of an application for approvals (Notice of Requirement to Alter Designation 3900: Auckland Prison in the Auckland Unitary Plan, Resource Consent and Outline Plan Waiver) by Department of Corrections on behalf of the Minister of Corrections - Project FTAA-2603-1179 (Auckland Prison Capacity Increase)

**REGULATORY ANNEXURES - MEMORANDUM OF PLANNING MATTERS FOR
AUCKLAND COUNCIL**

Dated: 28 July 2026

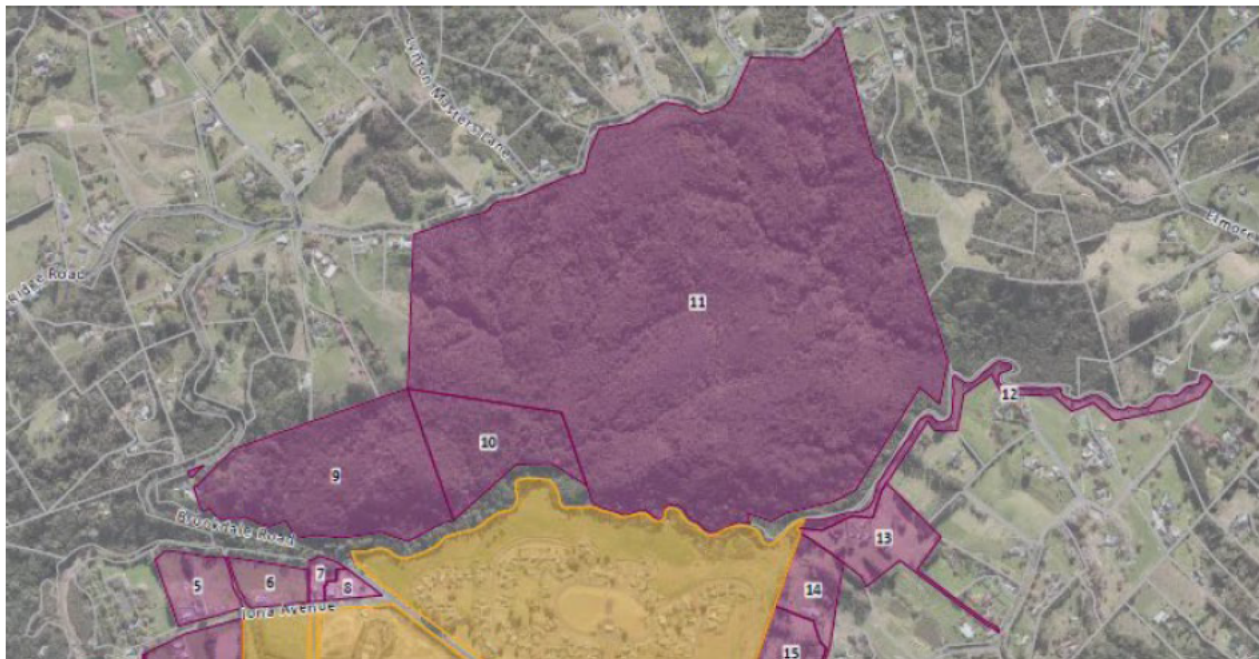
- The AUP(OP) open space underlying zoning will be the key regulatory planning control moving forward.
- Amendment of designation 3900 in this application (see Figure 1 – Volume 1 – Appendix 1C Site Plans snippet below) moves the designation boundary to south of Paremoredemo Road resulting in a buffer of the 'Prison Village' area separating Paremoredemo Reserve from the new designation boundary.

- No potential for more than minor adverse effects on Paremoredemo Reserve (9)(10), (11) and the Esplanade Reserve (363 Ridge Road) (12).
